## **CABINET MEMBER FOR ENVIRONMENT – 30 APRIL 2020**

### **WENDLEBURY: A41 – PROPOSED EXTENSION OF 40MPH SPEED LIMIT AND 50MPH SPEED LIMIT**

**Report by Interim Director of Community Operations**

Project title  
**A41 - Proposed 40mph extension  
 Proposed new 50mph  
 Schedule**

Drawing title  
**A41 Bicester**

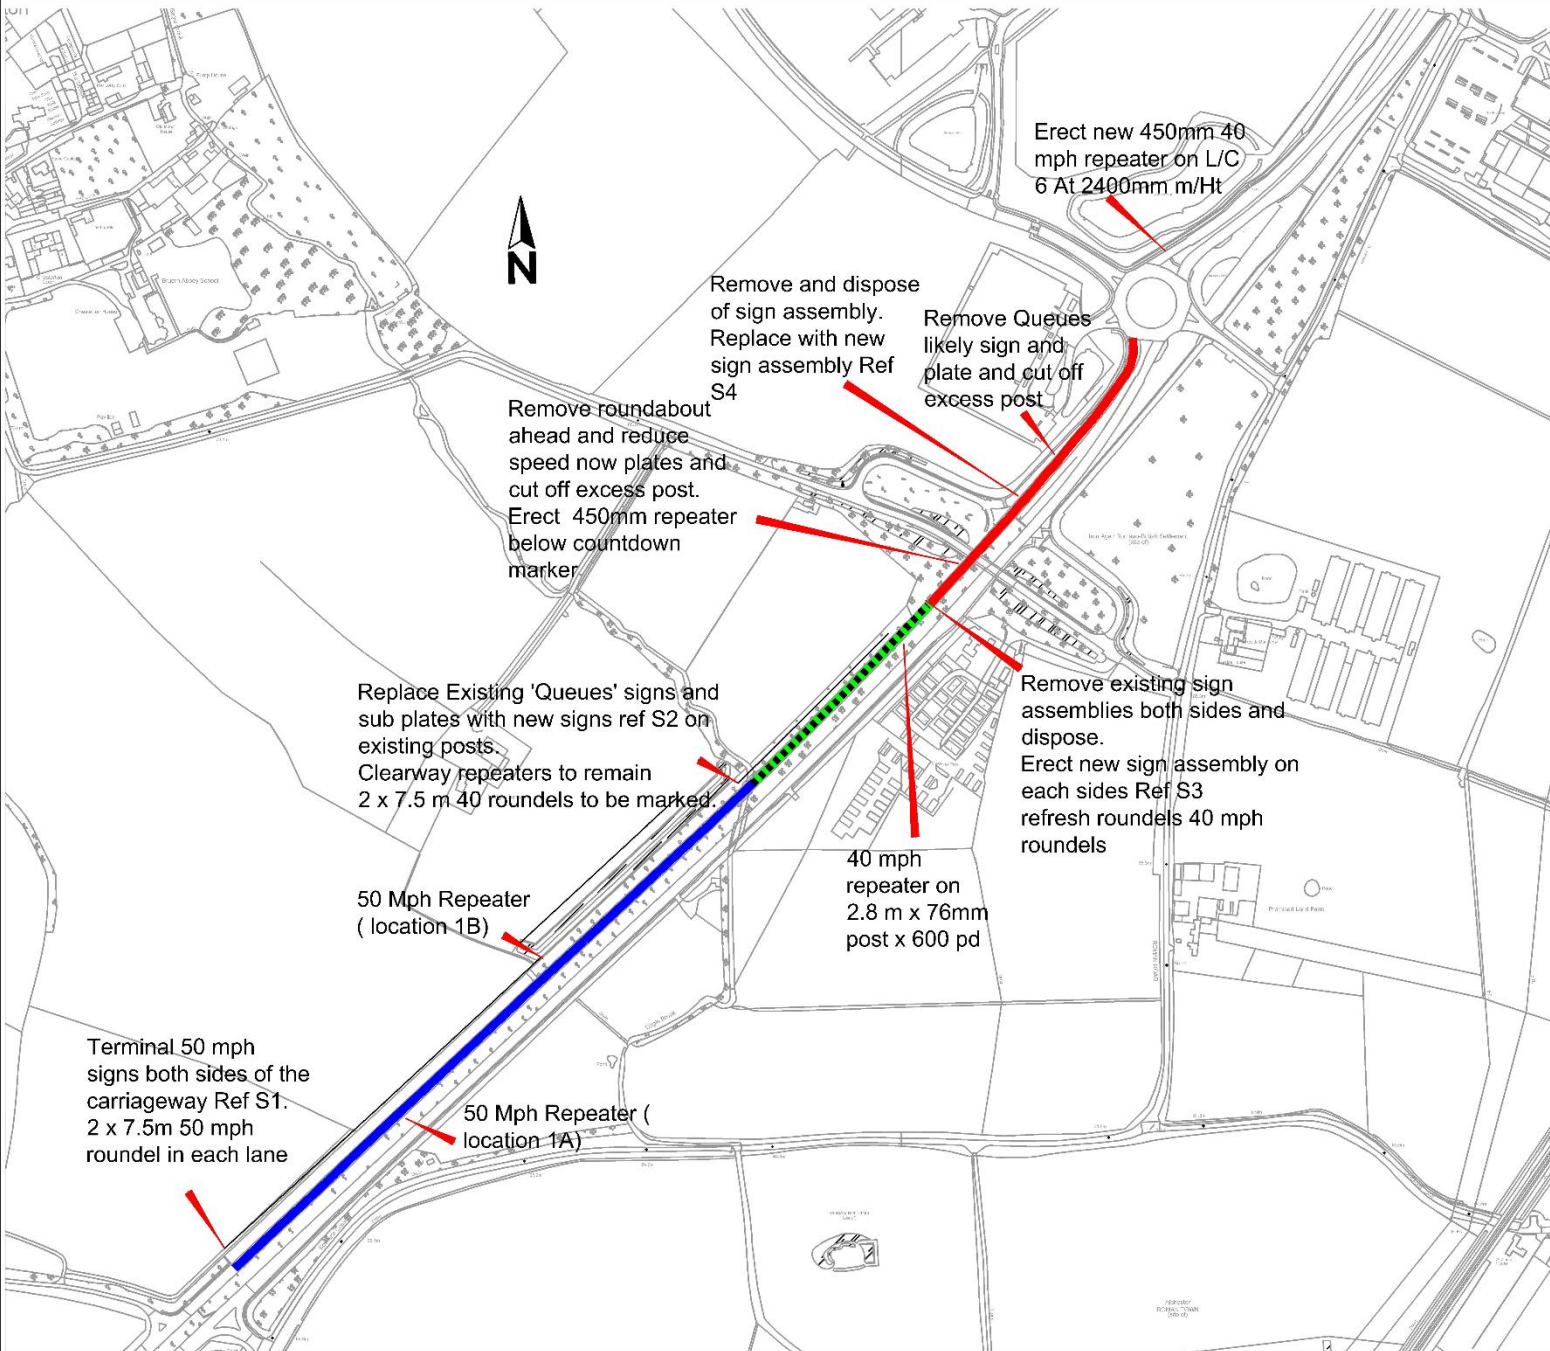
(2) Local County Cllr, (Otmoor Division)	<p><b>Object</b> - I do not believe a reduced speed limit is necessary on this stretch of road. There is plenty of time to change speed with the present restrictions. An earlier change in speed serves no purpose.</p>

(3) Local Town Cllr, (Bicester West)	<p><b>Concerns</b> - Unfortunately, I do not consider the Statement of Reasons and Public Notice to simply reduce the speed limit to have gone far enough to actually address the safety of road users using the Vendee Drive Roundabout.</p> <p>I have taken the opportunity to speak with local residents within my area about the considerations of amending the speed limit on the A41 to assist alleviating the problems of safety on and entry to the roundabout. The consensus of feedback was largely the same. The comments were from local residents using the area both frequently and infrequently. I myself have to use the area multiple times a day with my commute and see many of the issues on a daily too.</p> <p>Collated feedback is as such:</p> <ul style="list-style-type: none"> <li>• Attempting to reduce the speed limit from J9 northbound A41 will most likely have little impact on the actual speed of traffic on the carriageway unless enforced, and may be excessive for the 2.5miles to the problem area much like that around the Botley intersection of the A34.</li> </ul>

<ul style="list-style-type: none"> <li>• Extending the 40mph segment currently in place will have little impact on the actual speed of traffic. Vehicles currently slowing to 40 from the current 70mph actually create more problems, causing undertaking, and heavy braking. True this is attributed to the current speed of the road, however a vehicle travelling at 40 still tends to chance pulling out on traffic already with right of way. This has been openly witnessed countless times, and is largely terrifying whilst on the roundabout to the Park &amp; Ride, accessing Vendee Drive having vehicles pull out at speed.</li> <li>• Removing roundabout ahead signs would be detrimental to safety of users unfamiliar with the road layout.</li> <li>• Visibility of the actual roundabout due to the left hand curve in the road at 300 yards is a problem and could be attributed to some of the near misses.</li> <li>• The roundabout is currently accessed by 3 lanes which immediately close down to 2, actually on the roundabout for northbound traffic from A41 turning right; which will increase with the new developments and Southbound from A41 turning right, without any lane markings on the road surface causing poor lane discipline.</li> <li>• Trajectory of vehicles entering the roundabout northbound is poor due to the recessed entry/exit of the Park &amp; Ride.</li> <li>• Current layout of Southbound A41 Pioneer Way accessing the roundabout currently evokes vehicles to barely slowdown as the A41 beyond is an almost straight road and the offset roundabout largely does not slow traffic trajectory. Fencing to reduce visibility of traffic on the roundabout to help slow traffic might be something to consider.</li> <li>• Speed of entry to the roundabout from both North and South is a major problem, but is in part also caused by modern driving styles of poor lane discipline and non-indicating of direction intent.</li> <li>• Suggestions of raised yellow road painted rumble chevrons to warn and slow vehicles at both main entry points would be welcomed.</li> <li>• Requested lane markings on the roundabout itself, somewhat similar to those on the Cutteslowe indicating clear lane definition.</li> </ul>

<p>(4) Wendlebury Parish Council</p>	<p><b>Object</b> - The closing date for comment was 27 March 2020, and in view of our new meeting format, OCC's flexibility in receiving our response is appreciated.</p> <p>The Parish Council takes the view that reducing the national speed limit on the A41 from Junction 9 to Vendee Drive is</p>

The Parish Council is unable to support the proposals as there is a lack of information to make an effective judgement and therefore wish to formally object to the proposals on the following grounds:

1. There was no evidence base to support the case for the speed reductions, i.e taking into account the 85% percentile based on the current numbers of vehicles and the average speed, will the proposals be achievable?

2. There appears to be no assessment of the full costs or benefits of the proposals.
3. There is no assessment on the potential impact of the extra traffic generated by planning developments at Bicester Gateway. OCC has known for some time the unsafe conditions on the A41, yet continue to support development proposals. The Tritax Symmetry aspirations for a logistics park on land near Little Chesterton between the M40 and A41 (<https://tritaxsymmetry.com/projects/symmetry-park-oxford-north/>) will have a major impact on the speed proposal.

4. Proposals will not reduce speed danger. Surveys show some vehicles speed at over 100mph.
5. There is no discussion about enforcement of these proposals. The Parish Council believes, that a range of enforcement options should be considered, including mobile Police enforcement, average speed cameras and permanent monitoring from Chesterton Road Bridge, but no arrangements are shown on the plan.

The Parish Council is extremely disappointed that the proposals do not address the speeding traffic on the southern section from Vendee Drive to Junction 9 M40. Particularly as one of the fatal accidents occurred by the public right of way crossing from Wendlebury to Little Chesterton in August 2018.

1. Both sides of the carriageway should be given the same consideration.
2. A 50mph limit needs to be introduced on the entire length of the A41 from Junction 9 to Vendee Drive and vice versa.
3. Any speed reduction should also be part of route management strategies, for example a complete review of the Vendee Drive roundabout, by reducing the approach speed to 30 mph.
4. Vehicle-activated signs should be used as an additional measure to warn drivers of a potential hazard or to remind them of the speed limit in force.

(5) Local Resident, (Bicester)	<b>Object</b> - Rather than having a long stretch of reduced speed limit the 40 zone near the roundabout should be better enforced. A reduced speed limit for a greater length that necessary will just frustrate road users.

(6) Local Group, (Bicester)	<b>Support</b> - Although 'BicesterBUG' welcomes the new and extended speed restrictions on the A41, it does not address the real risk and concerns of active travel around the Vendee Roundabout which will remain a high-speed roundabout.  The safety of active travel (cyclists and pedestrians) crossing the arms or using the carriageway of the roundabout is still in question due to the wide entries and exit which must be crossed.

(7) Local Resident, (Bicester)	<b>Support</b> - This should have been done years ago as set out in the Safety Audit
(8) Local Resident, (Oxford)	<b>Support</b> - While I support the intent of the proposals, from observation the existing 40mph speed limit is seldom adhered to. At times, it is dangerous to do so as other traffic often has no intention of slowing down. Has the council considered installing a speed camera to enforce the new limits? As a motorist who uses this road daily I would very much support that.

7. Thames Valley Police did not object noting the poor safety record of the road which in part they consider to be attributable to the unconventional layout of the roundabout. If approved the scheme will include improved access for the police to operate mobile speed enforcement within the 40mph speed limit, which will also be facilitated by the proposed extension of this limit.

8. Councillor Sames, the member for the Otmoor division, objected on the grounds that the proposed speed limits were unnecessary.
9. A member of Bicester Town Council expressed concerns that the proposals will not appreciably address the safety problems at the roundabout which they attributed primarily to the layout of the roundabout, noted specific concerns with the proposed signing changes and made suggestions for additional traffic signs and road markings. These comments are noted and a further review of possible amendments and additions to the proposed traffic signs and markings will be carried out.

10. Wendlebury Parish Council objected and in their detailed response raised concerns over the evidence that was used in the assessment of the proposals (for example querying the availability of speed surveys), noting concerns over the impact of further possible development adjacent to this part of the A41 and also the actual effectiveness of the proposals without further information on speed enforcement.

11. A major concern of the parish council is the safety of pedestrians crossing the A41 to and from the bus stops and it is confirmed that an options appraisal is currently being carried out and will be made available to the council when completed. It is accepted that there has regrettably been a significant delay in progressing this work due to the very high workload of officers over the past year. The parish council's suggestions for a more extensive review of speed limits on the A41 to include both carriageways will form part of the options appraisal as will improved signing, including the possible use of vehicle activated signs. As noted above, the proposed works will include the provision of access for police mobile camera equipment in respect of the proposed speed limits. While it seems unlikely that the 30mph speed limit proposed by the parish council at the Vendee Drive roundabout would comply with national guidance on setting speed limits, as referred to above a further review of possible measures at the roundabout will be carried out.
